Chatham-Cary Joint Issues Committee

July 19, 2011

Overview of June 29 Public Comments

Does Disposition of MXD Node Affect Land Use on West Side of NC 751?

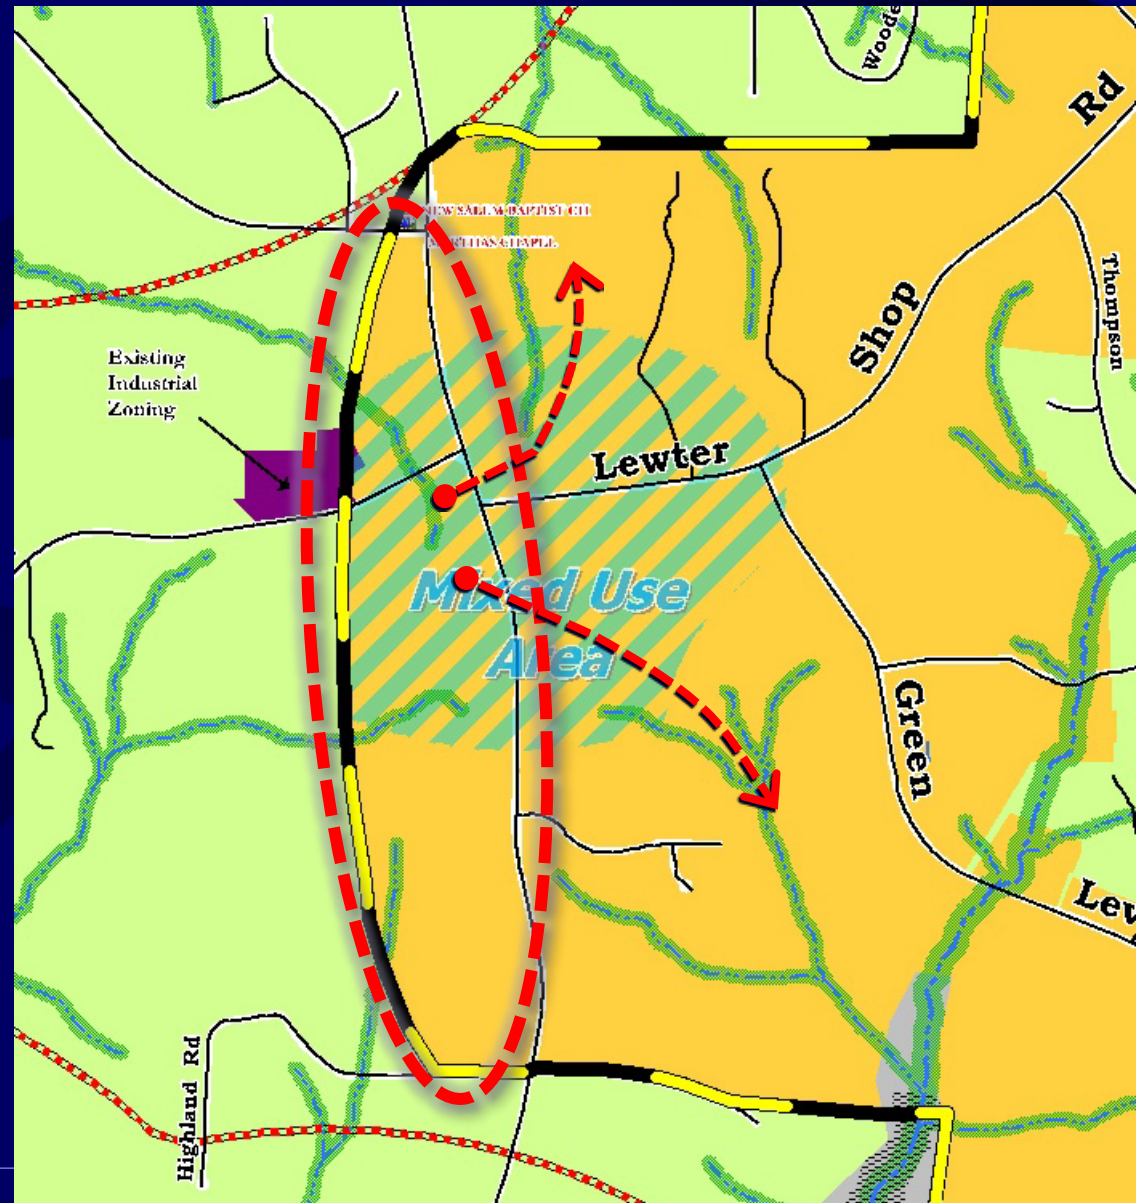
1. Mixed Use Nodes. Several citizens spoke requesting that the optional Mixed Use Nodes be deleted. After June 29, some owners requested NC751 node remain.

- The Plan Map allows for a limited amount of LDR and/or MXD uses on west side of NC 751, but...
- ...only if served by public sewer draining to the east side of NC751.
- If MXD node is removed, should LDR be allowed west of NC 751?

2. Horil/Hodge Properties:

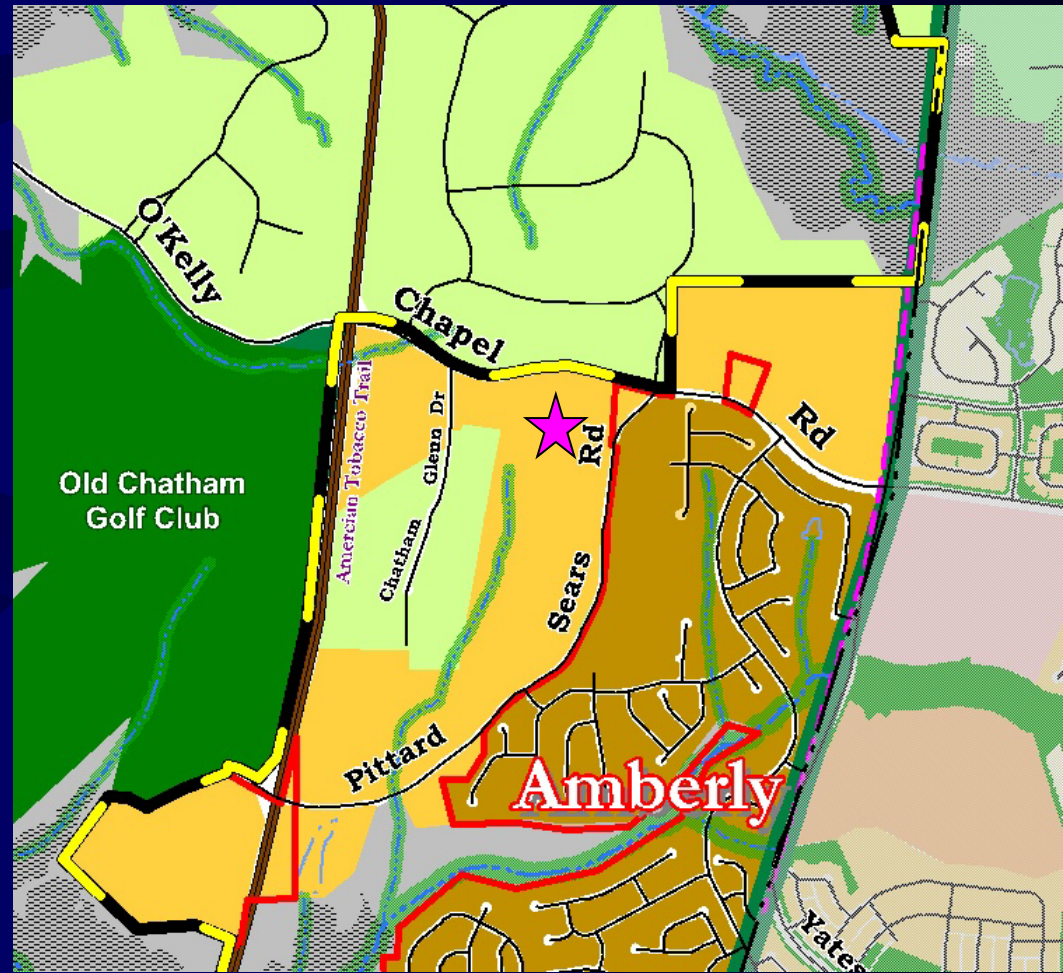
- Ø Owners want option for Assisted Living/Retirement Community also.
- Ø Other citizens asked for area to be changed to VLDR.
- Ø Whether or not the density is based on gross or net acreage affected how some viewed the LDR. (e.g., 1 du/ac might be OK if based on net acres (?))
- Ø Some citizens requesting VLDR also wanted the Rural Buffer Boundary moved back eastward as it was in Plan Map 5.
- Ø One adjacent resident requested Rural Buffer Boundary to stay as is.

Lost Corners, 2002 NW Area Plan:

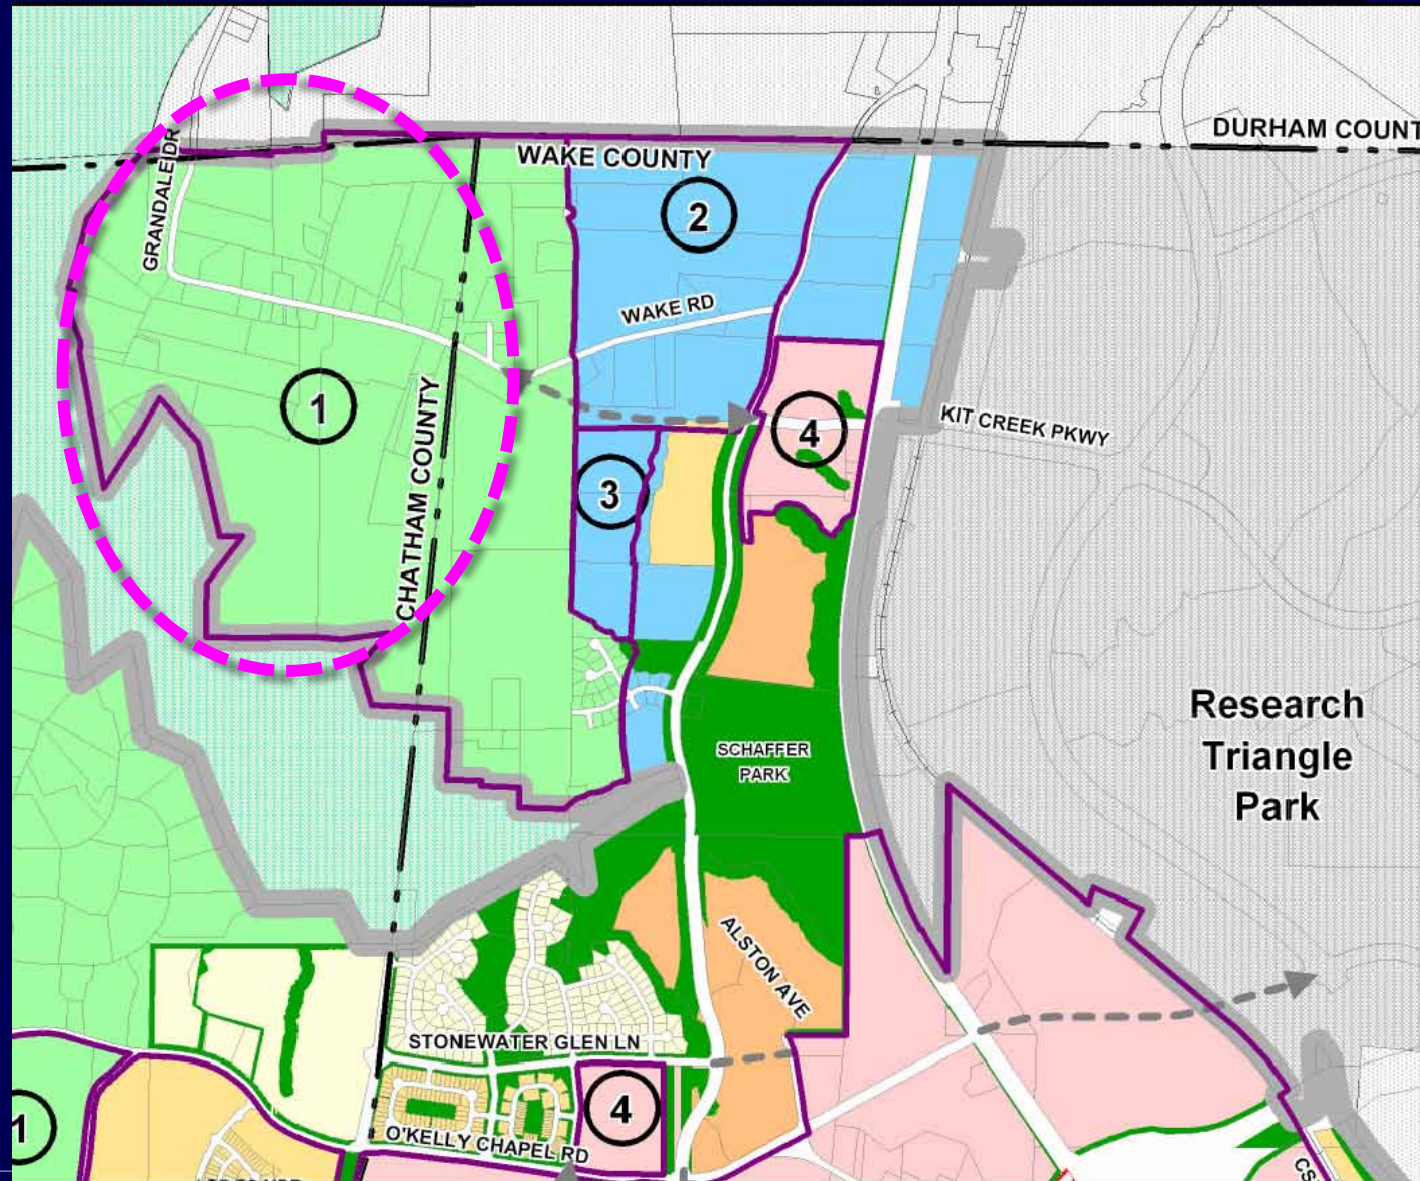
Note 1. No more than 1 du/5ac for conventional subdivisions; up to 1 du/ac for conservation (clustered) subdivisions.
